BUILDING PERMIT REPORT

REASON FOR PERMIT: To Construct a duplex dwelling

**CITY OF PORTLAND, ME
BOCA 1999 Plan Review Record
One and Two Family Dwelling**

Valuation: \$100,000.00 Plan Review # 1132/2K.
 Fee: \$624.00 Date: 24 July 2K
 Building Location: LOT 46, Maggie Lane. CBL: 292-A-036
 Building Description: 2 Family Dwelling
 Reviewed By: S. Hoffses

1ST FLOOR PLAN

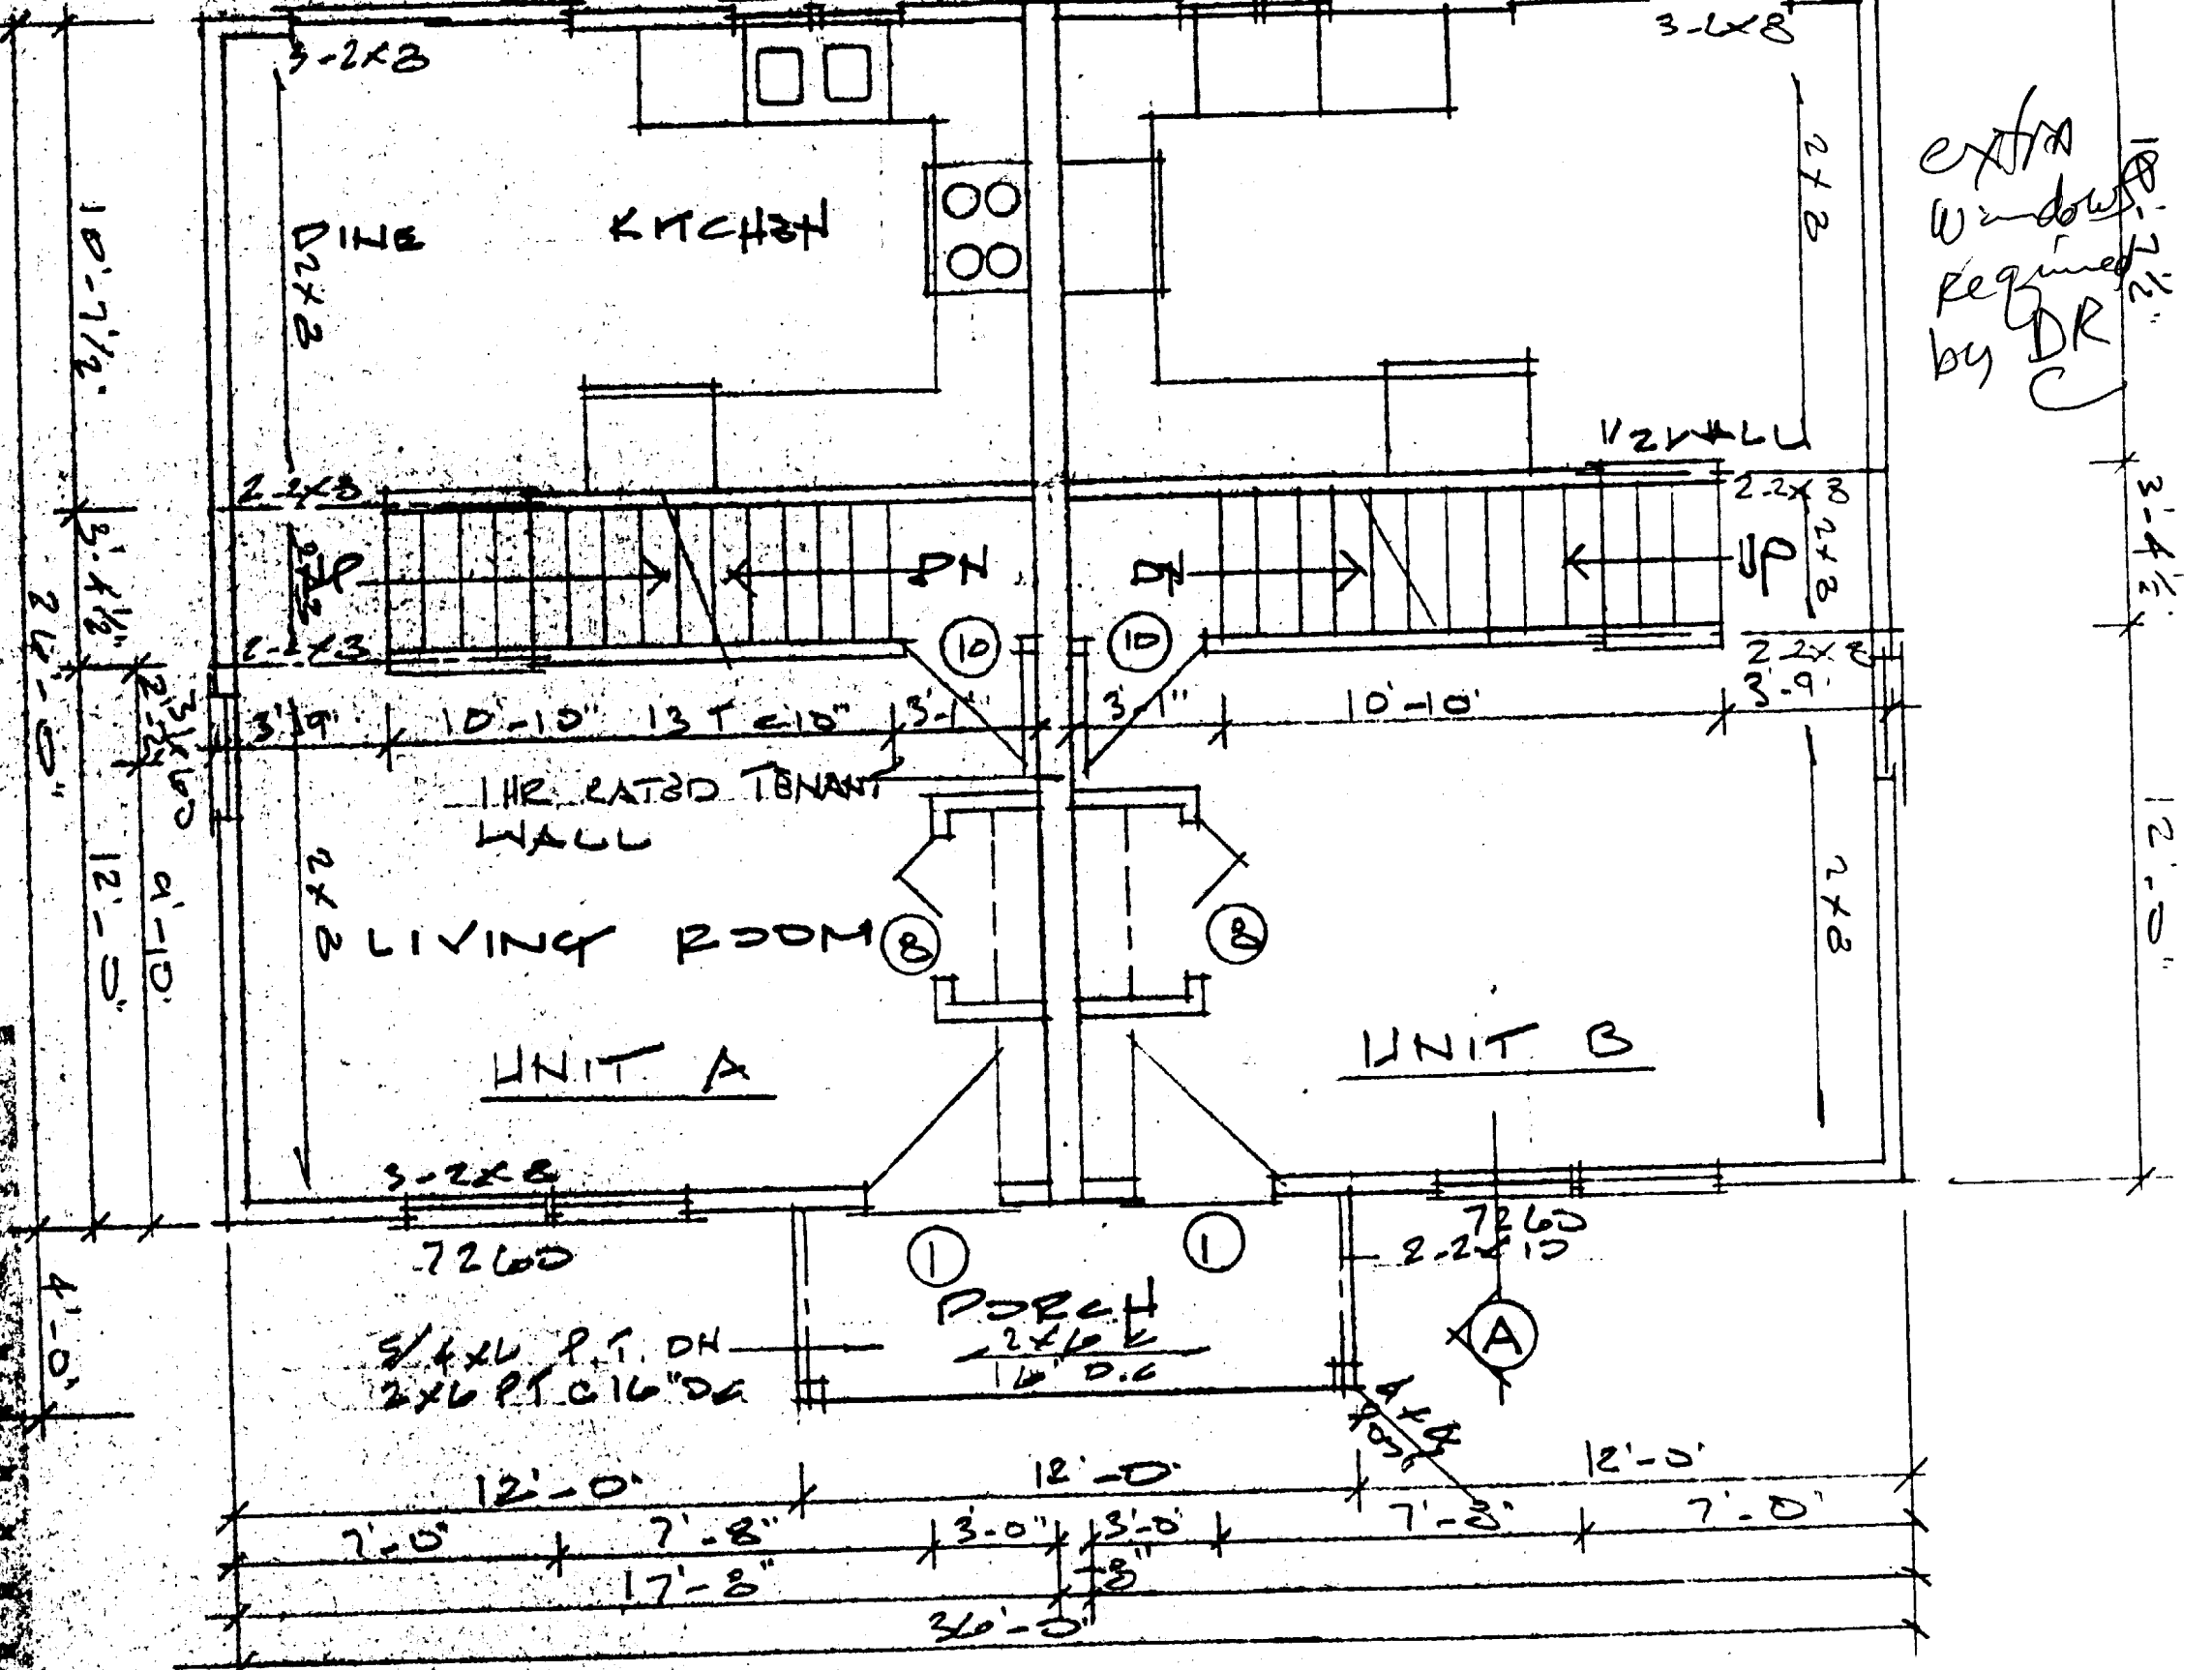
extra windows required by DR

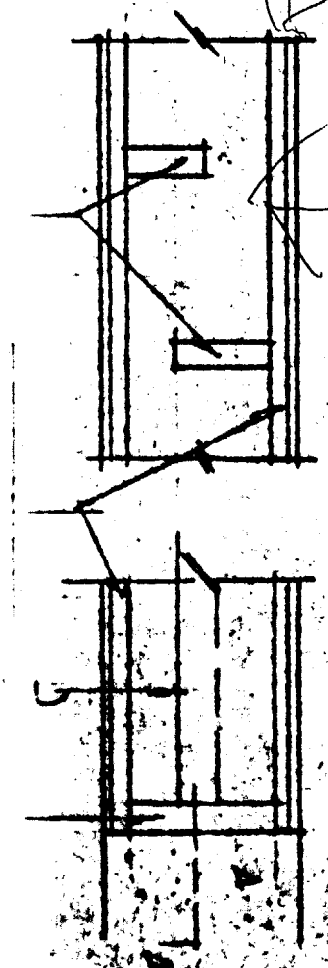
1 Hr Fire Partition
Sec. 711.0

Sec. 1211.0 Sound Trns

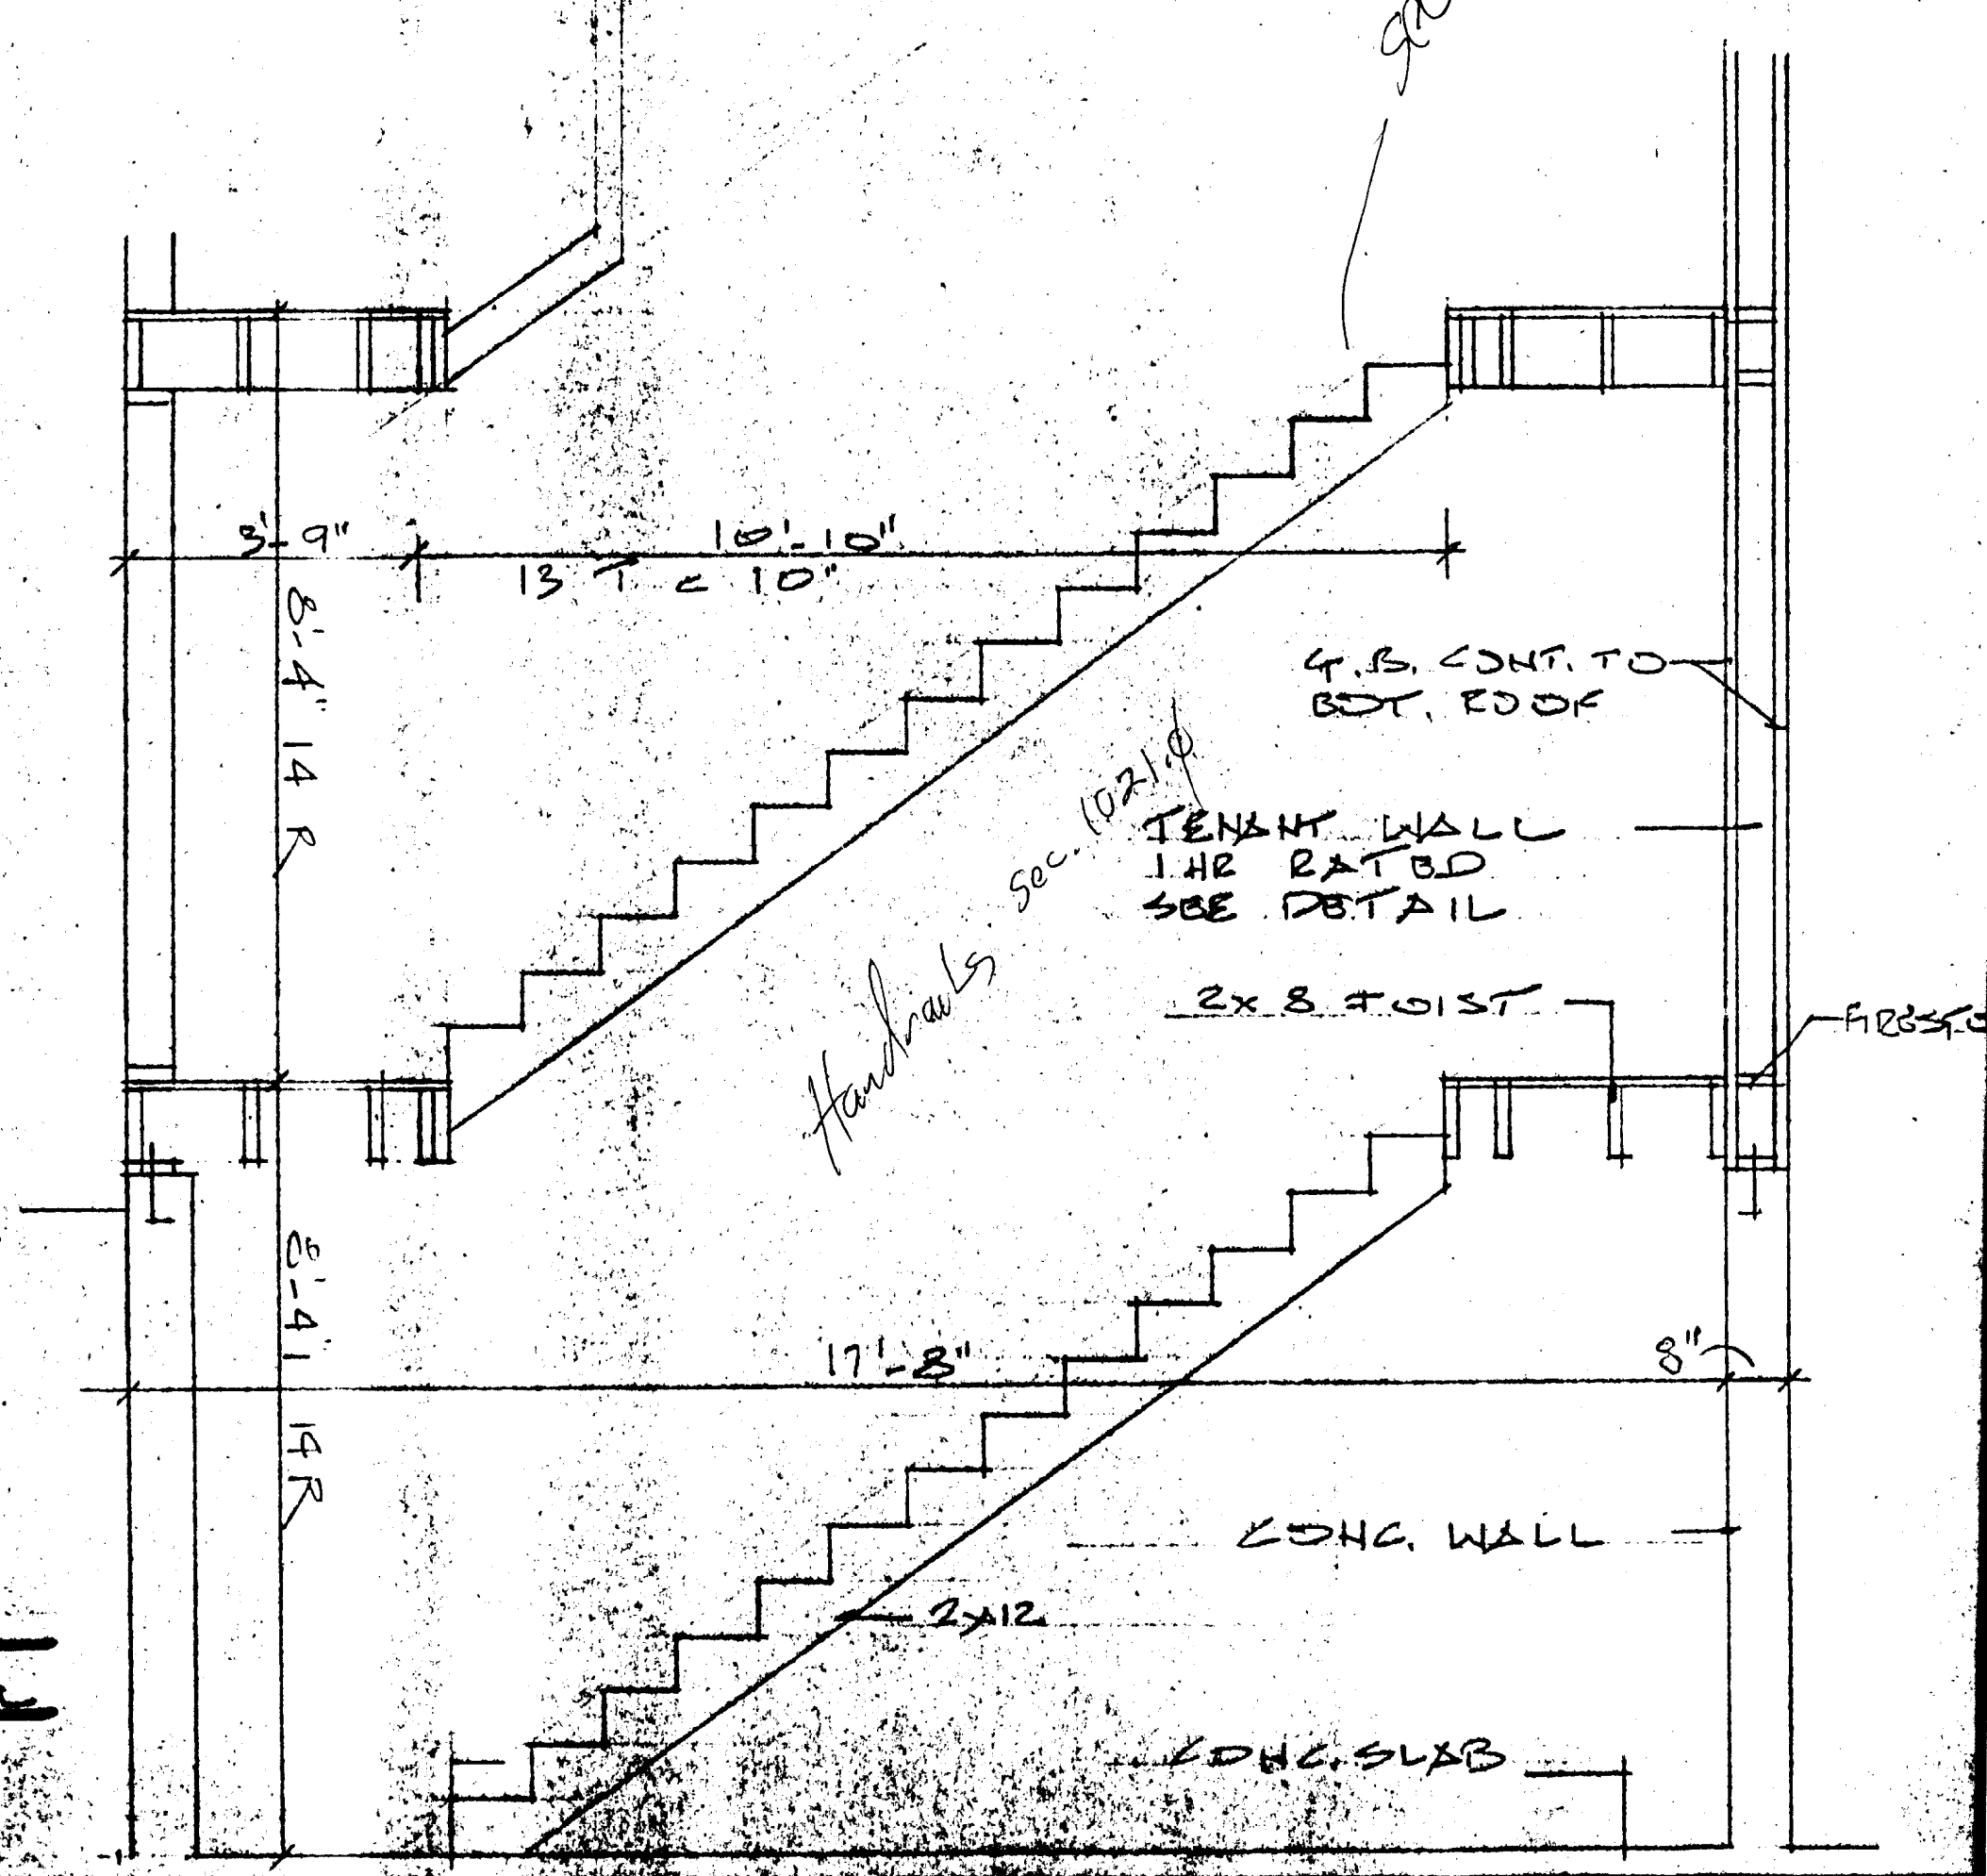
TENANT WALL
1 HR RATED
SEE DETAIL
